# UNITED STATES PATENT AND TRADEMARK OFFICE

APPLICATION NO.	FILING DATE	FIRST NAMED INVENTOR	ATTORNEY DOCKET NO.	CONFIRMATION NO.
10/822,007	04/12/2004	Hideaki Shimoda	251774US2	1570
22850	7590	07/14/2006	EXAMINER	
OBLON, SPIVAK, MCCLELLAND, MAIER & NEUSTADT, P.C. 1940 DUKE STREET ALEXANDRIA, VA 22314			GLENN, KIMBERLY E	
			ART UNIT	PAPER NUMBER
			2817

<b>Office Action Summary</b>	<b>Application No.</b>	<b>Applicant(s)</b>	
	10/822,007	SHIMODA, HIDEAKI	
	<b>Examiner</b>	<b>Art Unit</b>	
	Kimberly E. Glenn	2817

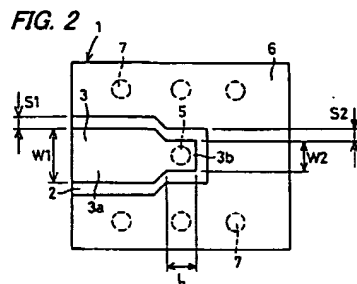
The primary reference Shirasaki disclose in figure 1 and 2, a high frequency wiring board comprising of a first line conductor 3 having a width of an edge portion 3b thereof being less than a width of another portion thereof; and a second line conductor 4 different from the first line conductor 3, which is connected to the edge portion of the first line conductor. The first and second line conductor disposed in different layers of a dielectric substrate 2 respectively. The edge portion 3b the first line conductor is arranged to overlap with the second line conductor; and a through conductor 5 is provided to connect said edge portion of said first line conductor to said edge portion of said second line conductor. (Column 5; line 7 through column 6; line 56) Figure 3 shows a conductor 8 for shortening the distance between the ground conductor 6 and the first and second line conductors (3 and 4). (Column 6 line 57-column 7, line 63)

Thus, Shirasaki is shown to teach all the limitations of the claim with the exception of a plurality of conductors provided to connect the edge portion of the first high frequency line to the end portion of the second high frequency transmission line.

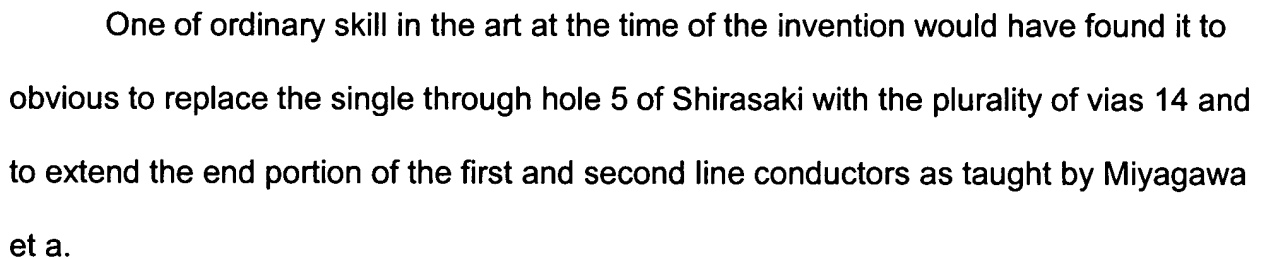
Miyagawa et al disclose in figures 5 and 6, a package comprising a conductive passage 70 having an inner lead section 70a, which have a width smaller than the width of the conductive passage section 70c. The inner lead section contains a plurality of conductive vias, which are used to connect the conductive passage 70 to horizontal metallic layer 15.

The motivation for this modification, even though not explicitly stated in the Miyagawa et al, one of ordinary skill in the would have known that the addition of a plurality of vias would increase the reliability of the electrical connection.

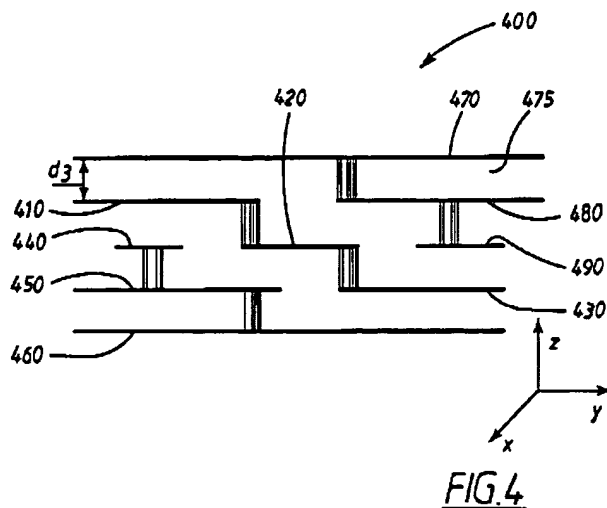
Harju et al disclose in figure 4, a transmission line arrangement comprising a first conductor section 410 in a layer of a dielectric substrate 475; a second conductor section 430 in a different layer of a dielectric substrate; a third conductor section 420 provided in a layer between said first conductor section and said second conductor section wherein one edge of said third conductor section 420 is overlapped with said first conductor section 410 and another edge thereof is overlapped with the second conductor section 430, a first connection conductor for connecting said first conductor section 410 to the one edge of said third conductor section 420 and a second connection conductor for connecting said second conductor section 430 to the another edge of said third conductor section 420. Harju et al further disclose a conductor 450 for shortening a distance between said first conductor section and a ground conductor 460. (Column 7; line 8 through column 9; line 3)

Thus, Harju et al is shown to teach all the limitation of the claims with the exception of the width of the third signal line being set to be between the width of the first signal line and second signal line.

One of ordinary skill in the art would have found it obvious to set the width of the third signal line to be between the width of the first and second signal lines, since such modification would involve a mere change in the size of a component. A change in sized is generally recognized as being within the level of ordinary skill in the art.
